Stratford Mining Complex Statement of Environmental Effects

RESPONSES TO SUBMISSIONS

Figure 3
Comparison of Stratford Coal Project Air Quality Contours

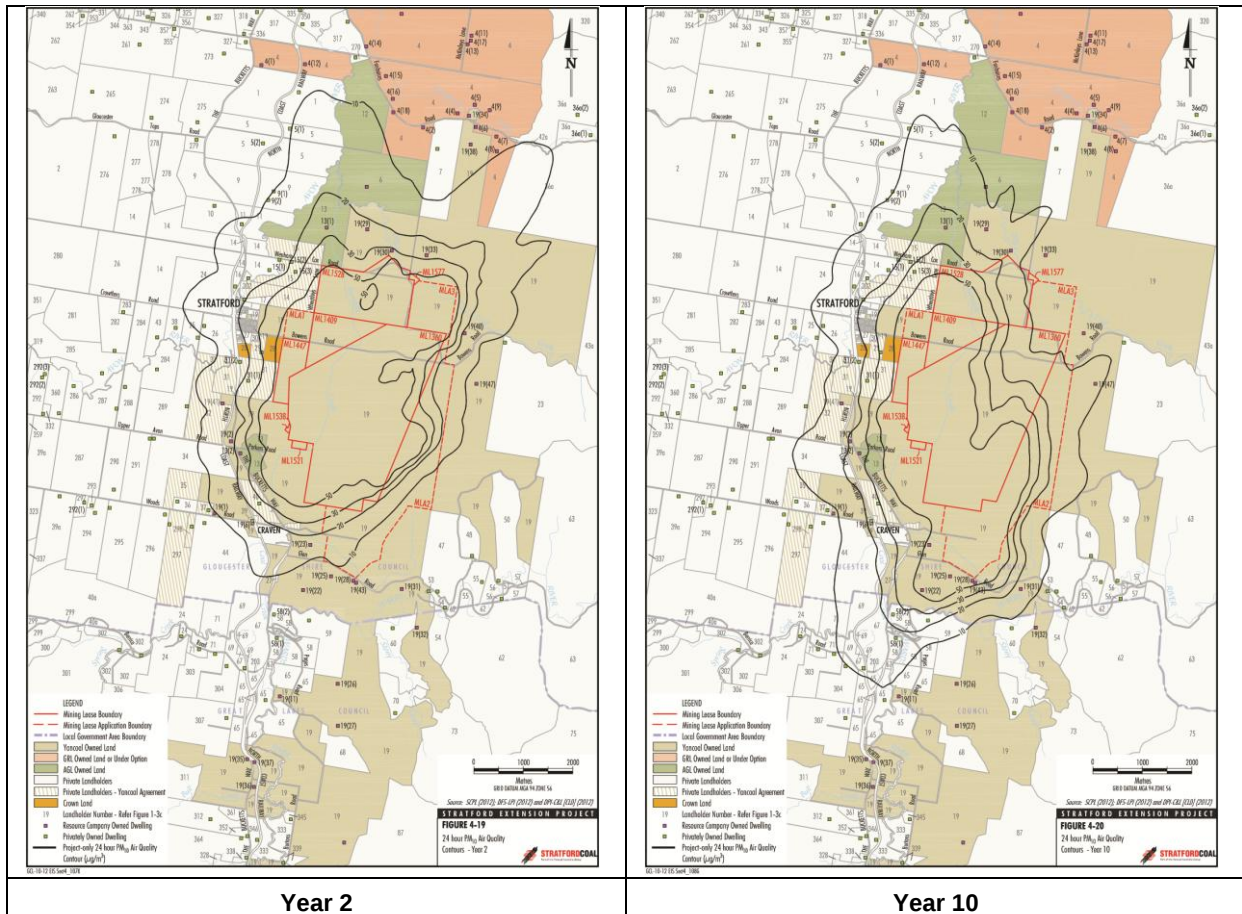
With reference to the comments in the submission from the EPA and Mid Coast Council, provide information which addresses the potential exceedances of mine-only air quality impacts in Year 10 of operations. The Air Quality Impact Assessment (AQIA) needs to specifically address the spatial relationships between air pollution sources and residential receivers to evaluate the potential for the modification to exacerbate the potential for exceedances.

The SEP EIS included air quality modelling of Years 2 and 10, with the resulting contours for 24 hour PM₁₀ shown in Figure 3. From review of the shape of these contours, it is apparent that Year 2 includes higher predicted emissions in areas to the north and east, whilst Year 10 shows higher emissions to the south.

Plate 1 Haul Road Control Efficiency Data Plot

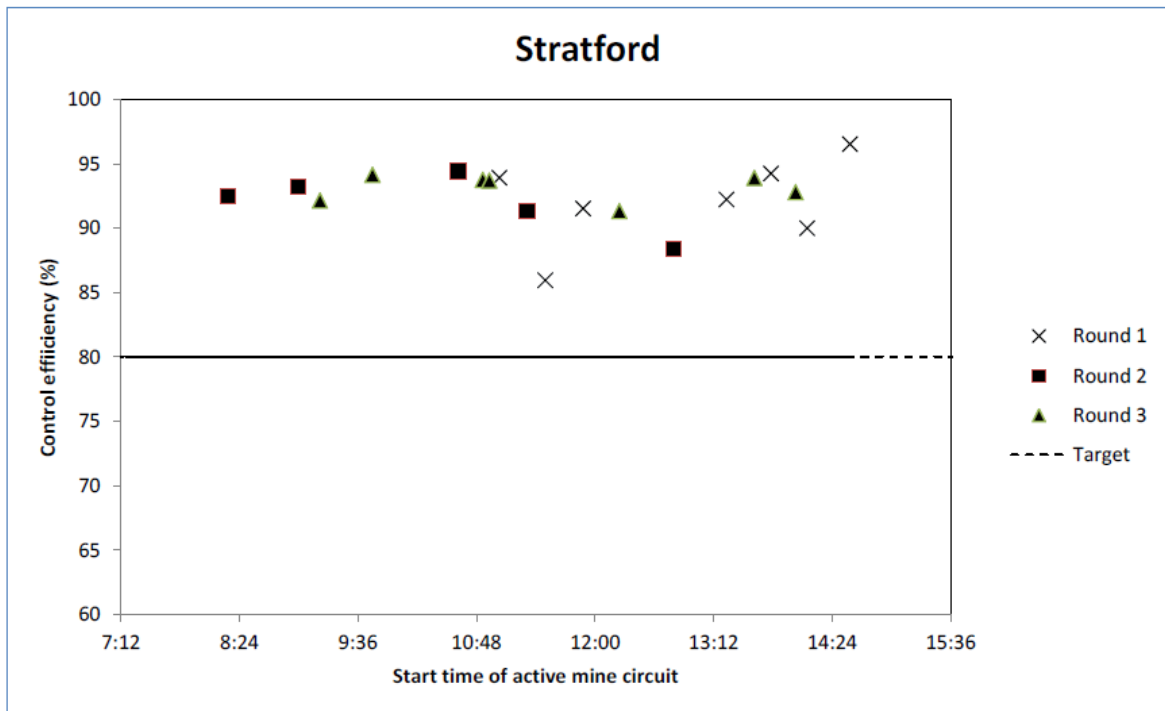
Yancoal should provide further justification of the 90% control rate used to estimate dust emissions generated by haul road use. Alternatively the AQIA should be re-assessed using 75% and 84% control rates for haul road dust emissions. The NSW Benchmarking Study demonstrates that a level of 75% effectiveness is achieved at 'level 2' watering, with a maximum of 84% effectiveness. If chemical suppressants are to be used, any potential impacts of chemical suppressants should be discussed.

A study of haul road dust control efficiency was undertaken by Pacific Environment Limited in 2014 (Pacific Environment Limited, 2014). This study used a mobile air quality emissions monitoring unit to measure emissions from unpaved roads under uncontrolled and controlled conditions and demonstrated a haul road control efficiency of greater than 90%. Plate 1 shows a plot of control efficiency data from the Pacific Environment Limited (2014) study. Accordingly, the 90% control efficiency assumed for this study (as well as for the SEP EIS) is consistent with the efficiency used in the SEP EIS and, therefore, is considered to be appropriate.
